MODIFICATION INSTRUCTIONS

KODAK MULTILOADER 700

Modification No. 17

To improve the function of the SWITCHES S1, S2 and S3.

figure 1

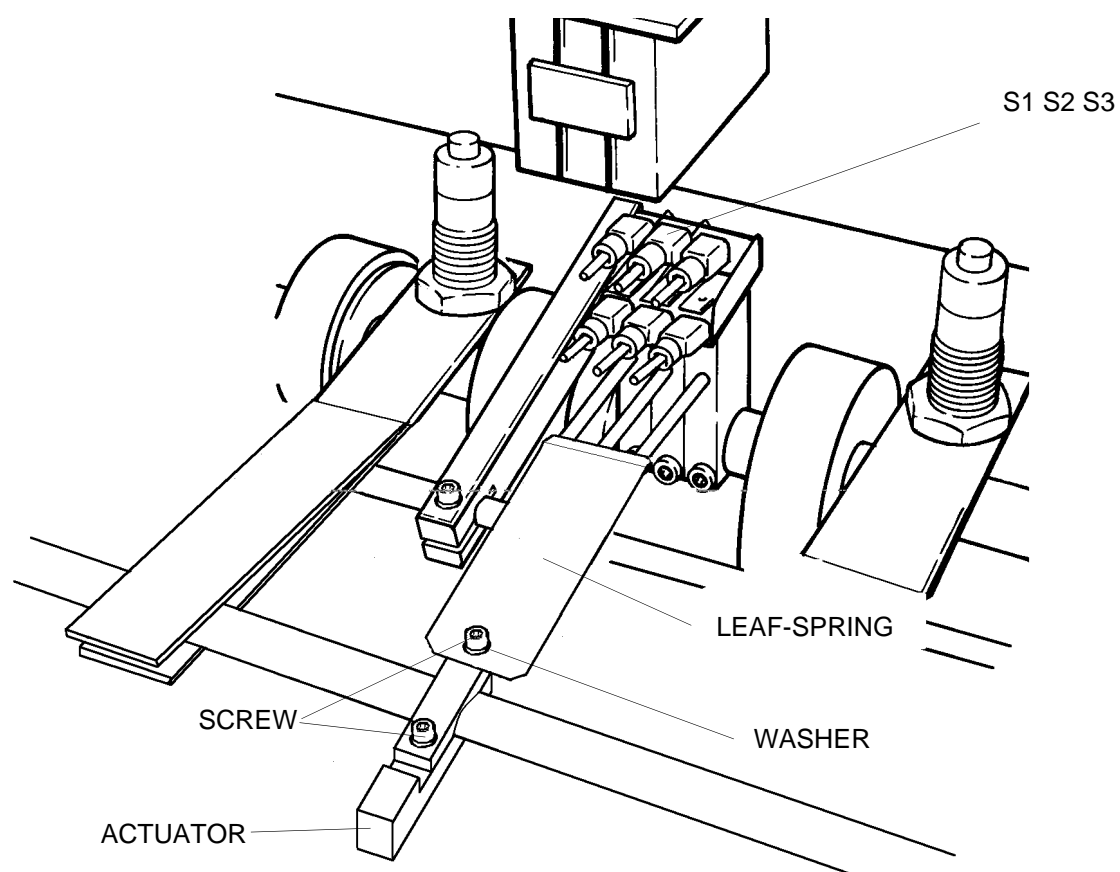
To prevent the ACTUATOR WIRES from the SWITCHES S1, S2 and S3 staying in the upper position, the LEAF-SPRING is installed.

1. Switch off the ML700.
2. Open the TOP COVER of the ML700 and secure it.
3. Mount the ACTUATOR and the LEAF-SPRING to the SHAFT.

4. Adjust the position of the ACTUATOR, that the LEAF-SPRING presses with little force onto the 3 WIRE ACTUATORS of S1, S2 and S3. Only a little force is needed to prevent the WIRE ACTUATORS from staying in the upper position. If the force is too high, it may result in CASSETTE TRANSPORT PROBLEMS.
5. Tighten the 2 SCREWS of the ACTUATOR.
